**ALTERATION TO A HISTORIC PROPERTY STAFF REPORT**

Site:	45 Tennyson Street	1875 Lawrence Spinney House
Case:	HPC 2014.038	Single Building Local Historic District
Applicant Name:	Jed Lippard, Owner	
Applicant Address:	45 Tennyson Street, Somerville, MA 02145	
Date of Application:	June 12, 2014	
Legal Notice:	<i>Remove landscape timbers &amp; asphalt driveway; and Replace with stone wall and unit block pavers</i>	
Staff Recommendation:	Certificate of Appropriateness	
Date of Public Hearing:	July 15, 2014

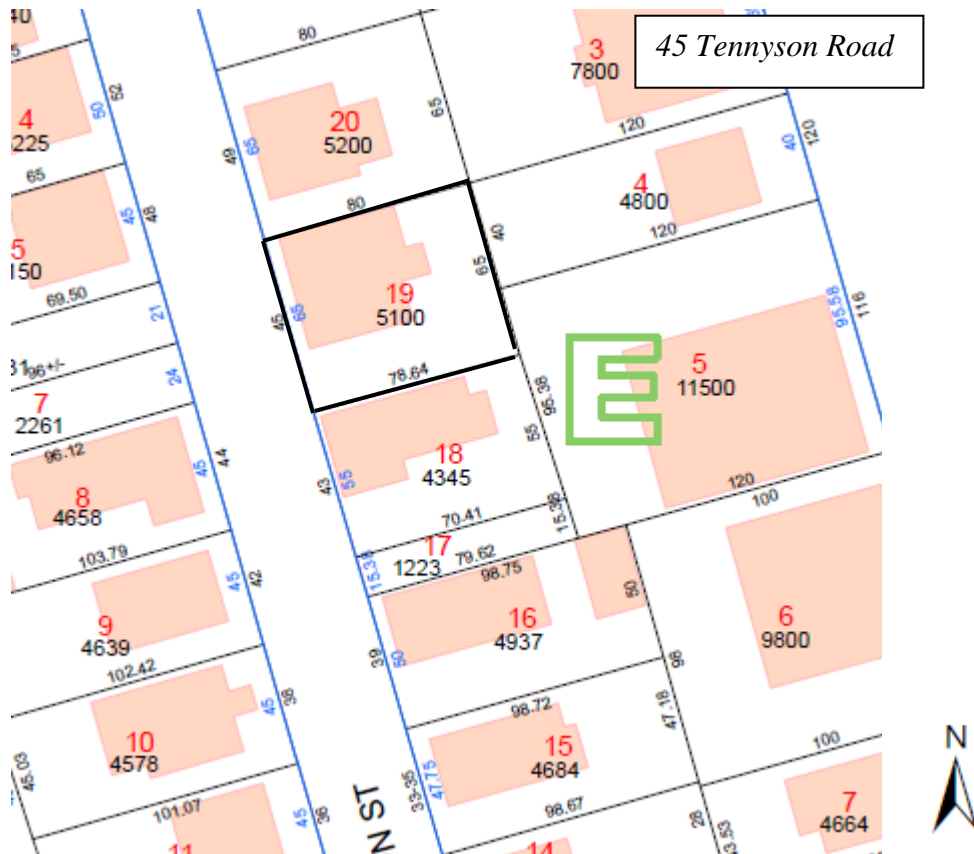
There will be no changes to the layout, only to the material of the driveway and walls.

The Applicant’s proposal for a unit block paved parking area will fit in with the neighborhood and not detract significantly from the street. The removal of the landscape timbers, which probably date from the 1950’s or 1960’s, would have no effect on the visibility or the layout. The installation of the pavers will clearly be modern.

1. The asphalt driveway shall be replaced with Unilock Camelot 6” x 6” pavers.
2. The rotted landscape timbers shall be replaced with a ‘dry-laid’ Pennsylvania fieldstone retaining wall.
